**FINAL
TECHNICAL MEMORANDUM
PHASE I RESULTS AND PROPOSED PHASE II FIELD ACTIVITIES
SWMU 50, FORMER AIRCRAFT WASH AREA NO. 2
NAS FORT WORTH JRB, TEXAS**

RESPONSE TO COMMENTS
Draft – Phase I Results and Proposed Phase II Field Activities
SWMU 50, Former Aircraft Wash Area No. 2
NAS Fort Worth JRB, Texas
Dated: April 2001
By: HydroGeoLogic Inc.

Comments by Michael Dodyk

Figure 1
Phase I Analytical Soil Results
Above Background
SWMU 50
Former Aircraft Washing Area No. 2

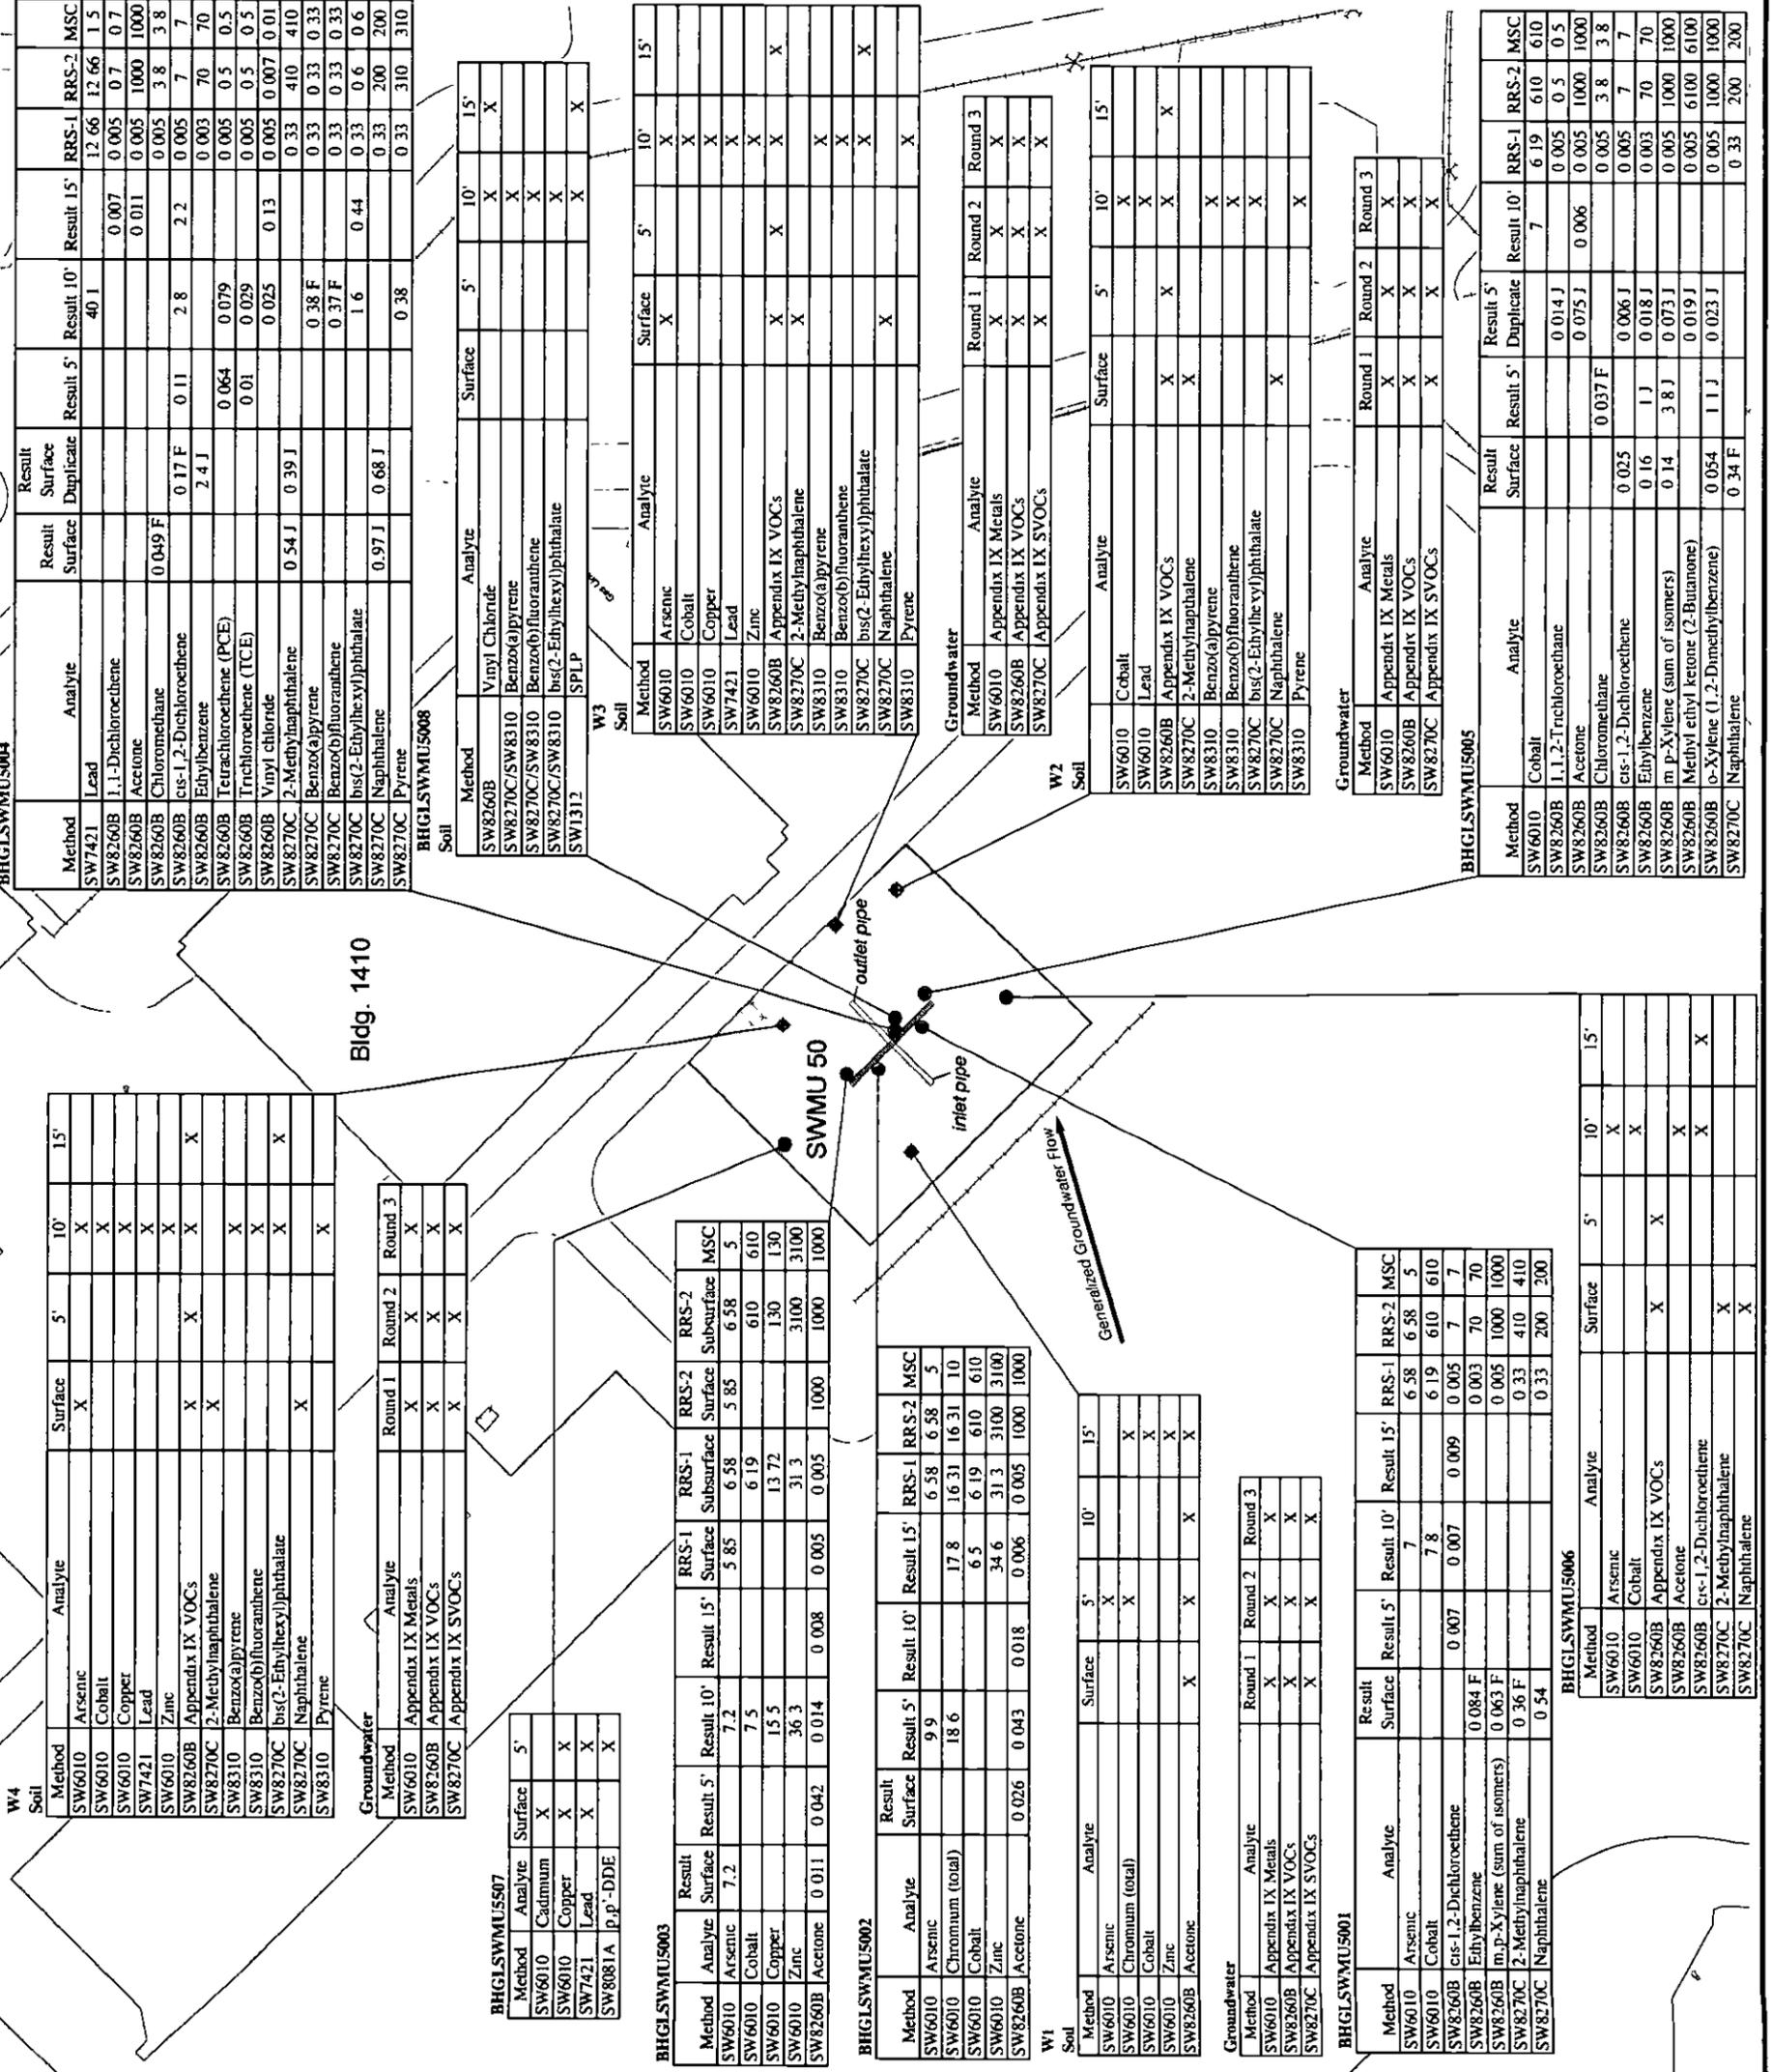
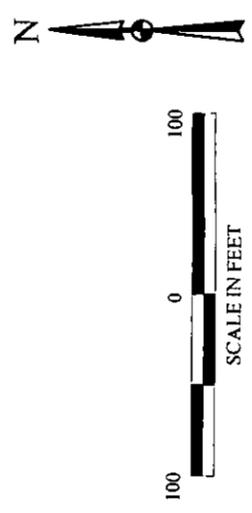
Comment 5. Figure 1: If the pending SPLP results do not establish a new MSC for chromium, please consider either confirming the chromium hits at B5002 (5' and 15') or delineating down gradient.

Response. The SPLP results have been added to the document. A revised MSC has been established for chromium in soil and chromium is delineated downgradient by boring B5004.
